# Access Compliance Report

## Public Rights-of-Way

Intersection ID: 45131	Main Street: PLAZA_RD_EXT	Cross Street: FOUR SISTERS_LN	Location: SW
ADA ID: 94E85A659F4F	Ramp Type: Perp	Initial Pass/Fail: Fail	Overall Compliance: No
Severity Score: 10			
Codes/Mitigation Info/Possible Solution		Field Measurements/Component Compliance

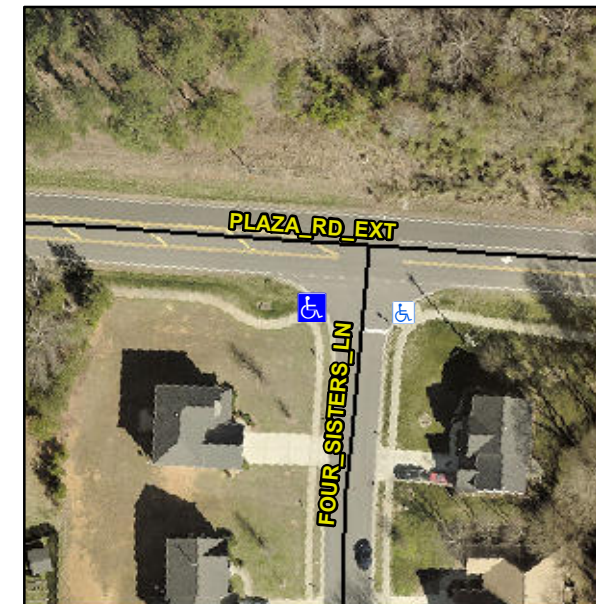
**Not Found, R304.5.1, R304.5.3**

Compliance	Description	Data	Compliance	Description	Data
N/A	Ramp Length (in)	52.0	Yes	Ramp Slope (%)	5.6
No	Ramp Width (in)	47.0	No	Ramp XSlope (%)	3.6
N/A	Flare Type LT	N/A	N/A	Flare Type RT	N/A
N/A	Flare Slope LT (%)	N/A	N/A	Flare Slope RT (%)	N/A
N/A	Flare Traversable LT?	N/A	N/A	Flare Traversable RT?	N/A
N/A	Landing Length (in)	N/A	N/A	DWS Provided?	N/A
N/A	Landing Width (in)	N/A	N/A	DWS Contrast?	N/A
N/A	Landing Slope (%)	N/A	N/A	DWS Length (in)	N/A
N/A	Landing X Slope (%)	N/A	N/A	DWS Full Width?	N/A
N/A	Landing Curb? (Y/N)	N/A	N/A	DWS Offset (in)	N/A
N/A	Shared Landing?	N/A			
N/A	Gutter Ponding?	N/A	N/A	Gutter Slope (%)	N/A
N/A	Gutter Lip Ht (in)	0.5	N/A	Gutter X Slope (%)	N/A
N/A	Painted X Walk1?	No	N/A	Painted X Walk2?	N/A
	X Walk 1 Direction	To SE		X Walk 2 Direction	N/A
N/A	X Walk 1 Width (in)	N/A	N/A	X Walk 2 Width (in)	N/A
	X Walk 1 Slope (%)	1.5		X Walk 2 Slope (%)	N/A
	X Walk 1 X Slope (%)	2.5		X Walk 2 X Slope (%)	N/A

**Remove & Replace Entire Ramp.**
